HORSHAM DISTRICT COUNCIL CONSULTATION

TO:	Horsham District Council – Planning Dept
LOCATION:	Land East of Mousdell Close Rectory Lane Ashington
DESCRIPTION:	Erection of 74 dwellings with associated access, parking and landscaping.
REFERENCE:	DC/25/1327
RECOMMENDATION:	Advice/ Modification/ More information
SUMMARY OF COMMENTS & RECOMMENDATION: The proposed development, as supported by the submitted Arboricultural Impact Assessment (AIA), Arboricultural Method Statement (AMS) and Tree Protection Plans (TPP), however, concerns are raised with incursions into Root Protection Areas (RPAs), and poor spatial relationships between retained trees and new dwellings, which are likely to impact on existing trees and give rise to future pressure for robust surgery works, or in the worst case their removal.

Root Protection Area (RPA) Conflicts

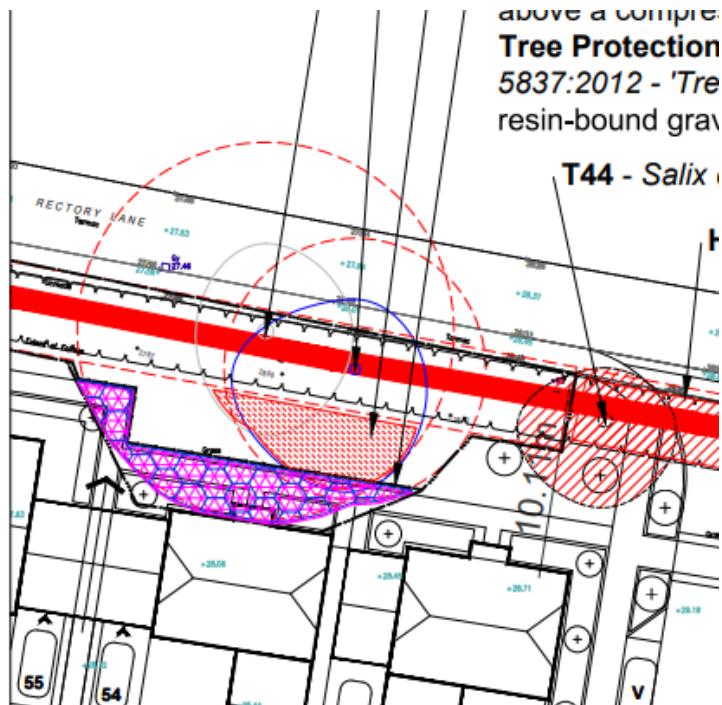
Several Category B and C trees and groups identified for retention are shown with building footprints or private gardens extending significantly within their RPAs. BS5837:2012, Clause 5, requires development layouts to be based on accurate tree constraint plans that avoid RPA incursions wherever possible. In places, the layout appears to have been fitted around existing trees without due regard for their rooting requirements, thereby failing the first principle of avoidance.

Affected trees and hedges include H01, T02–T09, T14–T23, T34, T36, T38, a portion of SC39, and T42–T43.

Under BS5837:2012, Section 5.3.1, incursions into RPAs should only occur where overriding justification can be demonstrated, supported by appropriate mitigation. No such justification or mitigation has been provided. Given the undeveloped, greenfield nature of the site, there appears to be no reasonable justification for development within RPAs of retained on or off-site trees.

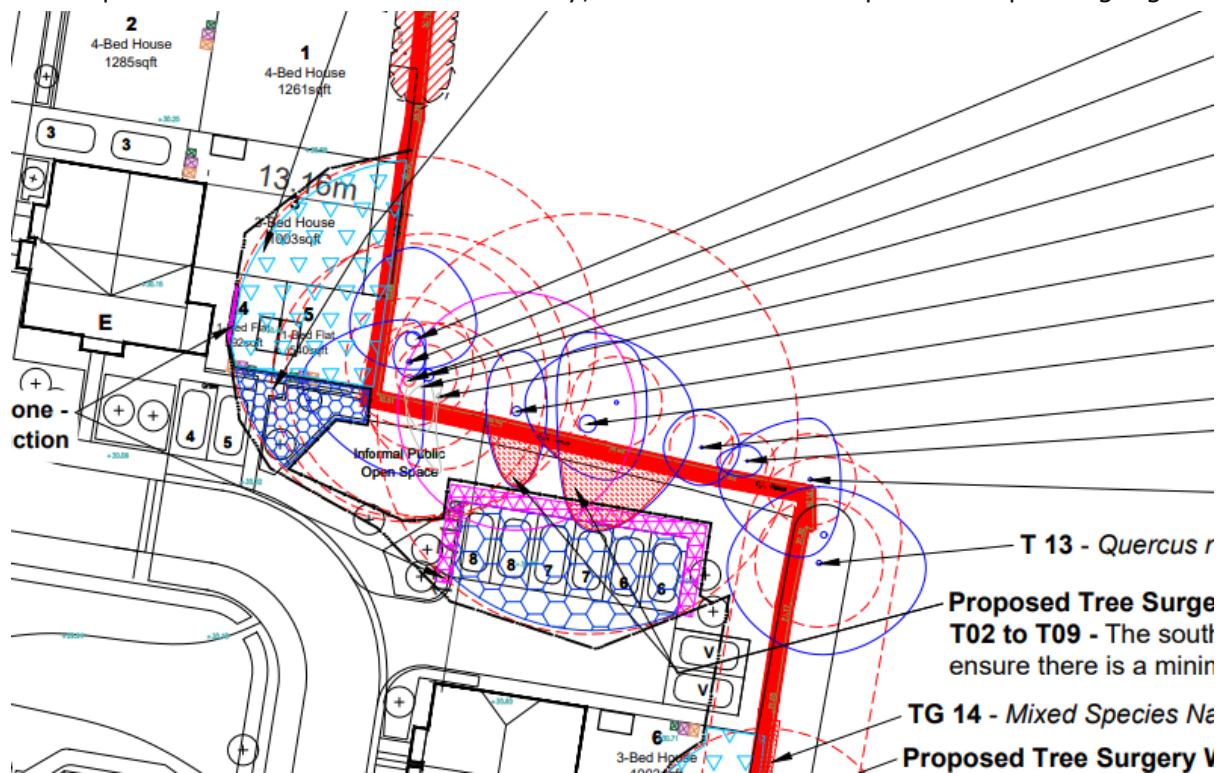
The proposed development encroaches on the Root Protection Areas (RPAs) of several off-site trees, as shown on the plan below. Although these trees are of limited individual quality, collectively they form an important visual and screening feature for the adjacent property, making their retention desirable for the adjacent property. Construction activity within the RPAs has the potential to adversely affect tree health through soil compaction, root damage, or changes to ground levels. The use of above-ground construction techniques in this area would be necessary, as the AIA and tree protection plan highlights.
